Planning Application PLN22/0537 at 2 Brendan Avenue, Doncaster for the construction of four, three-storey dwellings and construction of a front fence.

File Number: IN25/475
Responsible Director: Director City Planning and Liveability
Applicant: Chinh Mai
Planning Controls: Residential Growth Zone – Schedule 2 (RGZ2), Design and Development Overlay – Schedule 8-1 (DDO8-1)
Ward: Tullamore Ward
Attachments: 1 Decision Plans
2 Legislative Requirements
3 Objector Map (confidential)

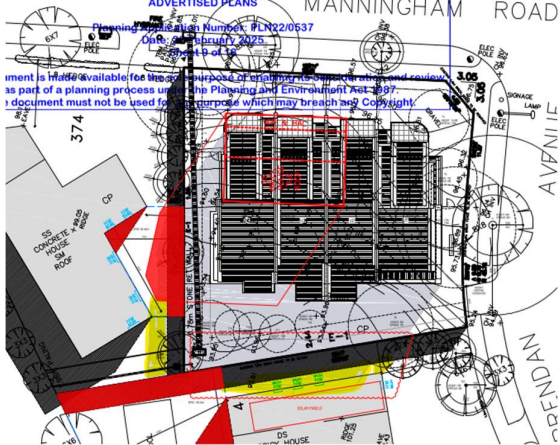
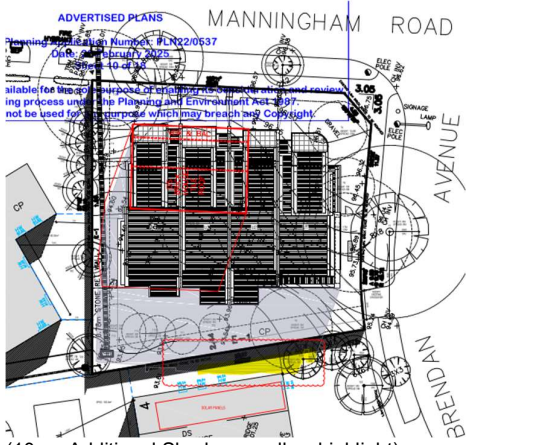
55.04-5 Overshadowing open space <ul style="list-style-type: none"> To ensure buildings do not significantly overshadow existing secluded private open space. 	Standard Met <ul style="list-style-type: none"> The shadow diagrams submitted indicate that there will be additional overshadowing to the secluded private open space areas of two adjoining properties by shadows cast beyond the boundary fence at 9am and 10am.

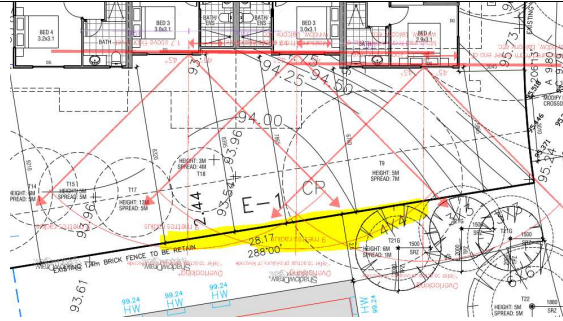
- It is considered that the southern boundary fence appropriately limits overlooking. A permit condition will require sectional diagrams to clearly demonstrate that the second floor south-facing windows are in compliance with Standard B22 of Clause 55.04-6 of the Manningham Planning Scheme.

- Furthermore, a condition on the permit will also require a boundary fence with a minimum of 1.8 metres on the southern boundary to provide appropriate screening from the driveway.
